**20-VARIANCE-0033, 20-
WAIVER-0027 and 19-WAIVER-
0008**

West Broadway Commercial

Louisville Metro Board of Zoning Adjustment

August 3, 2020

Proposed Site Plan with area of requests

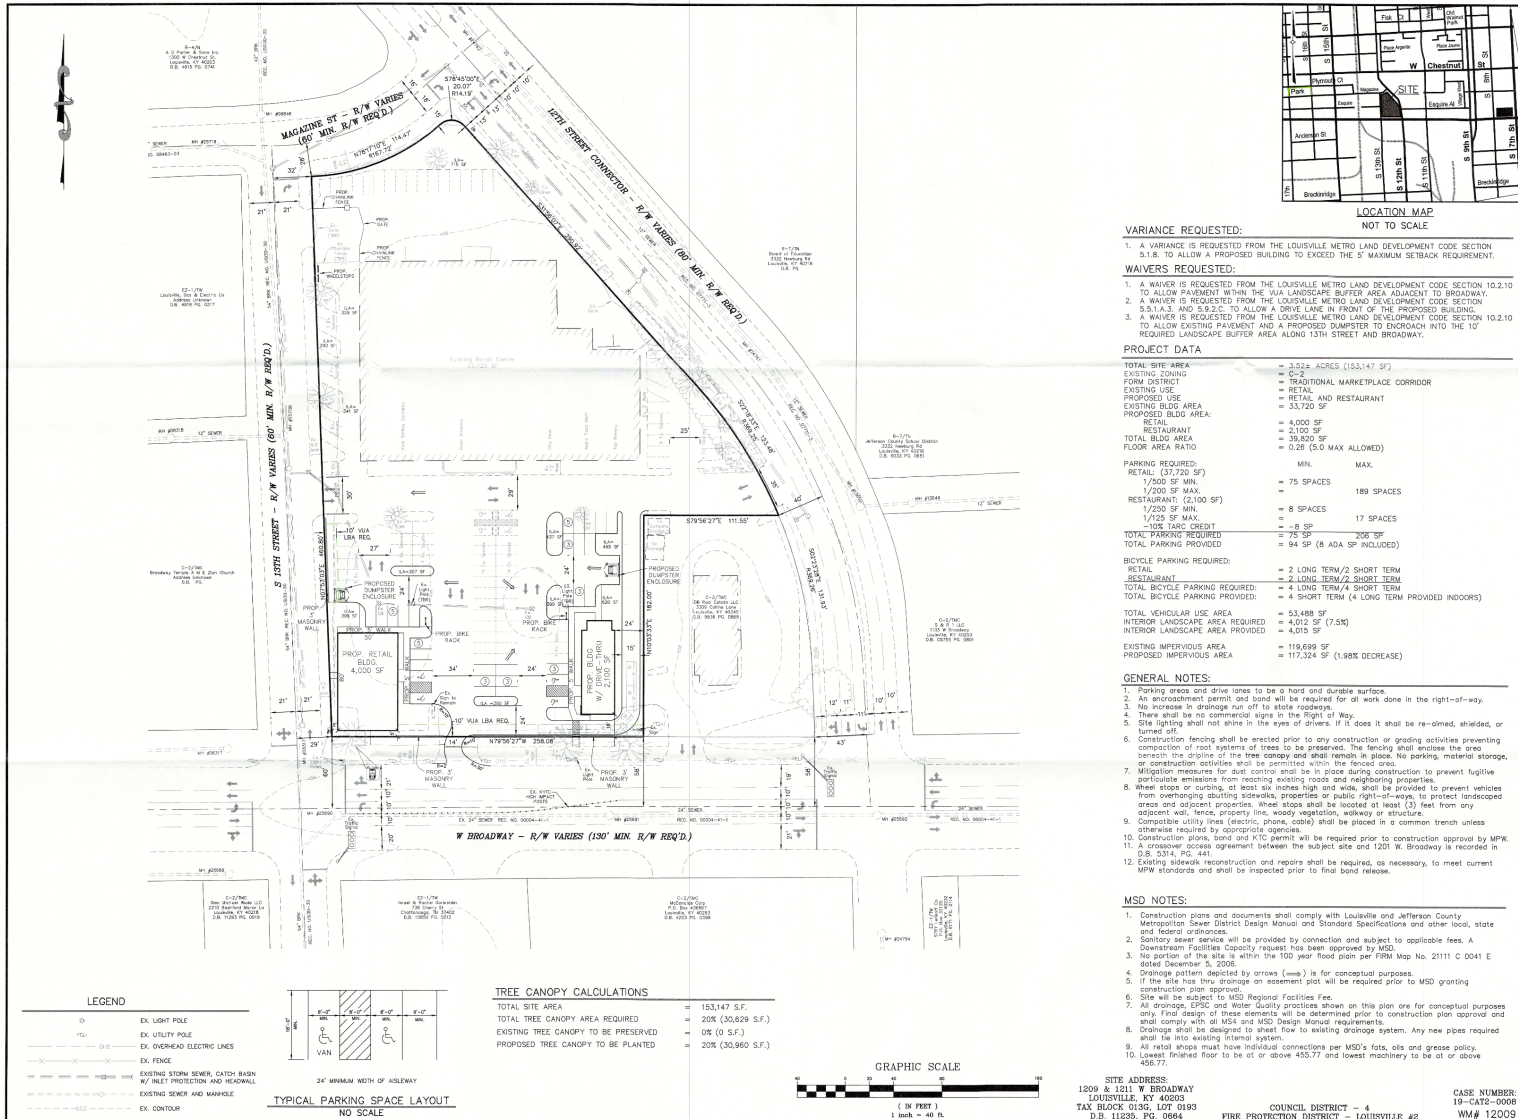
- The requests are adequately justified and meets the standard of review.
- The existing development is significantly non-conforming to the setback rules for the Traditional Marketplace Corridor form district. The new development will bring commercial activity closer to the front of the site, which will bring the site further into compliance with current regulations. The development will increase the density of neighborhood serving uses on a previously developed site.
